Meeting Minutes: 2024 UPC ad hoc Rulemaking Committee of the Plumbing Board

Date: August 7, 2024
Time: 9:00 a.m.
Minutes by: Lyndy Logan
Location: DLI, 443 Lafayette Rd. No., St. Paul, MN 55155

MHD 132 (0)(3)
ISLAND FIXTURE VENTING

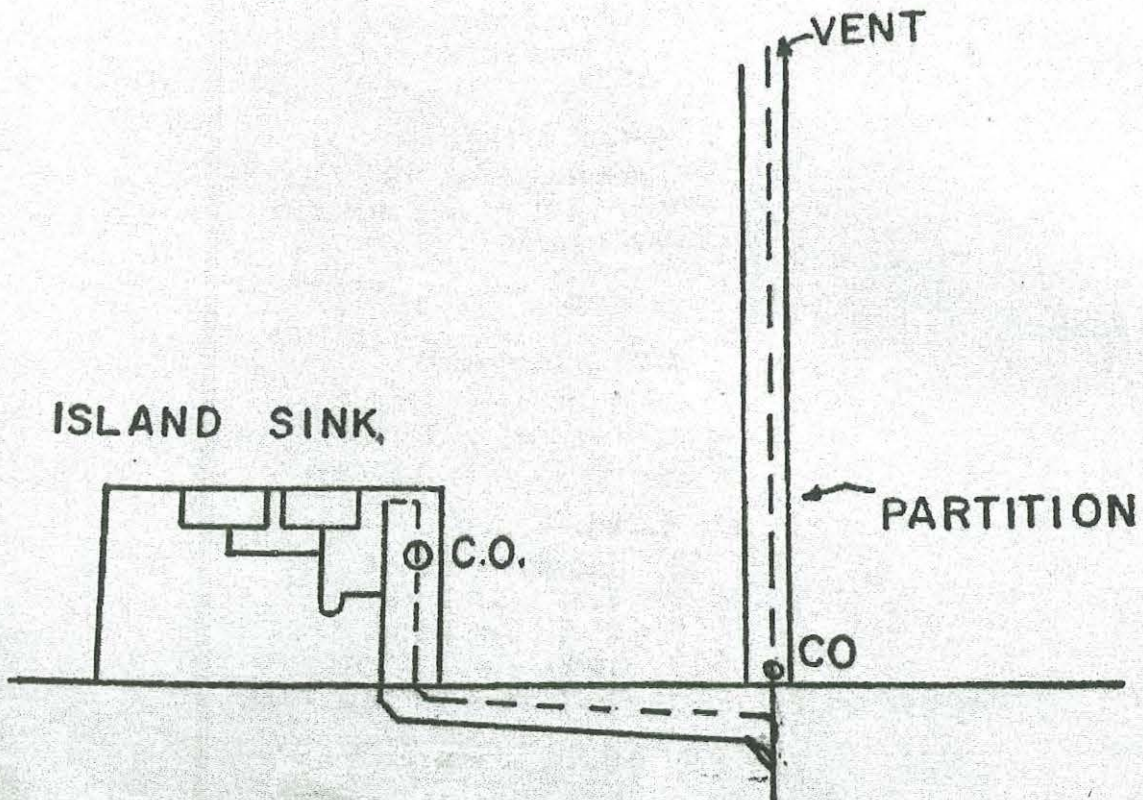
- 909.1 – keep as shown in the 2024 UPC with the addition of MDH 132 (O)(3) Island Fixture Venting diagram – **table until an RFA is received from DLI looking at how to incorporate language to include the illustration of MDH 132 (O)(3) Island Venting diagram – see Attachment A.**

- The proposed language below was discussed but not approved/finalized.
 909.1 General. Traps for island sinks and similar equipment shall be roughed in above the floor and shall be permitted to be vented by extending the vent as high as possible, but not less than the drainboard height and then returning it downward and connecting it to the horizontal sink drain ~~immediately~~ downstream from the vertical fixture drain. The return vent shall be connected to the horizontal drain through an approved drainage wye branch fitting and shall, in addition, be provided with a foot vent taken off the vertical fixture vent by means of an approved drainage fitting wye branch ~~immediately~~ below the floor and extending to the nearest partition and then through the roof to the open air, or shall be permitted to be connected to other vents at a point not less than 6 inches (152 mm) above the flood-level rim of the fixtures served. Drainage fittings shall be used on the vent below the floor level, and a slope of not less than 1/4 inch per foot (20.8 mm/m) back to the drain shall be maintained. The return bend used under the drainboard shall be a one-piece fitting or an assembly of a 45 degree (0.79 rad), a 90 degree (1.57 rad), and a 45 degree (0.79 rad) elbow in the order named. Pipe sizing shall be as elsewhere required in this code. The island sink drain, upstream of the returned vent, shall serve no other fixtures. An accessible cleanout shall be installed in the vertical portion of the foot vent.

909.2 Combination Waste and Vent for Island Sinks. A combination waste and vent system for island sinks shall be permitted. The waste pipe shall be a minimum 3 inches (80 mm) in diameter undiminished in size from the kitchen sink trap connection. The trap shall connect to a 3x3x1½-inch sanitary tee with a 3-inch cap on top of the tee. An accessible 3-inch cleanout shall be provided at the base of the kitchen cabinet. The vent shall be a minimum 1½ inches (40 mm) in diameter and connect to the horizontal waste pipe no greater than 15 feet (4.6 m) from the trap connection. The trap shall be sized in accordance with Section 1003.3.
